## SUMMARY OF CONCERNS IN RELATION TO THE PROPOSED NORTHCONNEX TUNNEL

**This is an objection to many aspects of the proposed NorthConnex tunnel.**

## SECTION A: THE CONNECTIVITY OF NORTHCONNEX SOUTHERN VENTILATION FACILITY AT THE SOUTHERN INTERCHANGE, THE SOUTHBOUND TUNNEL IN PARTICULAR

MOTORWAY OPERATIONS COMPLEX - SOUTHERN VENTILATION FACILITY - SECTIONS  
M1-M2-5000-DR-JD-0525

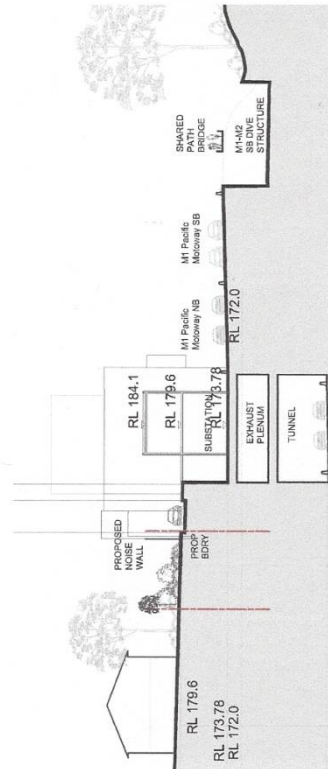
6. *EIS Volume 4, Technical working papers Urban Design, 8.0 Landscape Design*  
EIS Page 176 is the diagram "Motorway Operations Complex – Southern Ventilation Facility – Site 1-1". *Page 13 below* The diagram does not show any connection to either the northbound or southbound tunnel. In the same Landscape Design section, EIS Page 182 is the diagram "Wilson Road Tunnel Support Facility –Section" *Page 14 below* which clearly shows the connection to the tunnels. In the same Landscape Design section, EIS Page 189 is the diagram "Northern Ventilation Facility – Landscape Concept Section". *Page 15 below* This also clearly shows the connection to the tunnels.

- Diagrams need to be provided showing the inter-relation between the shaft, the ventilation outlet and the motorway operations centre with a clear description of what is to be constructed and how it will operate.
- The community needs irrefutable evidence that the polluted air from the southbound tunnel exit portals will not be allowed to flow like an invisible sewer through West Pennant Hills, North Rocks, Carlingford and Beecroft.

M1-M2-5000-DR-UD-0556  
NORTHERN VENTILATION FACILITY - LONG SECTION

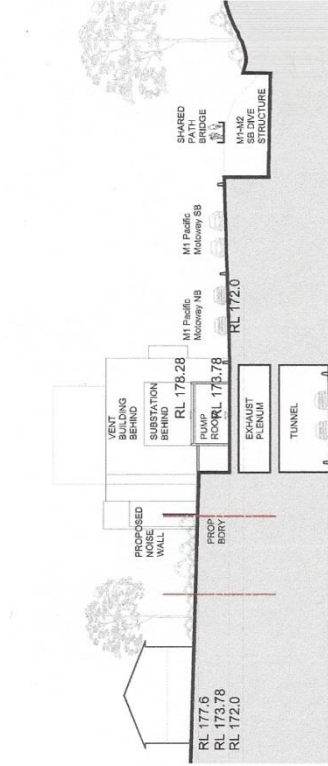
EIS page 135 *Page 11 below* there is a very explicit diagram showing the *Northern Ventilation Facility – cross section*.

EIS page 134 *Page 12 below* there is a very explicit diagram showing the *Northern Ventilation Facility – long section*.

Why are there no comparable diagrams for the Southern Interchange and the Southern Ventilation facility?
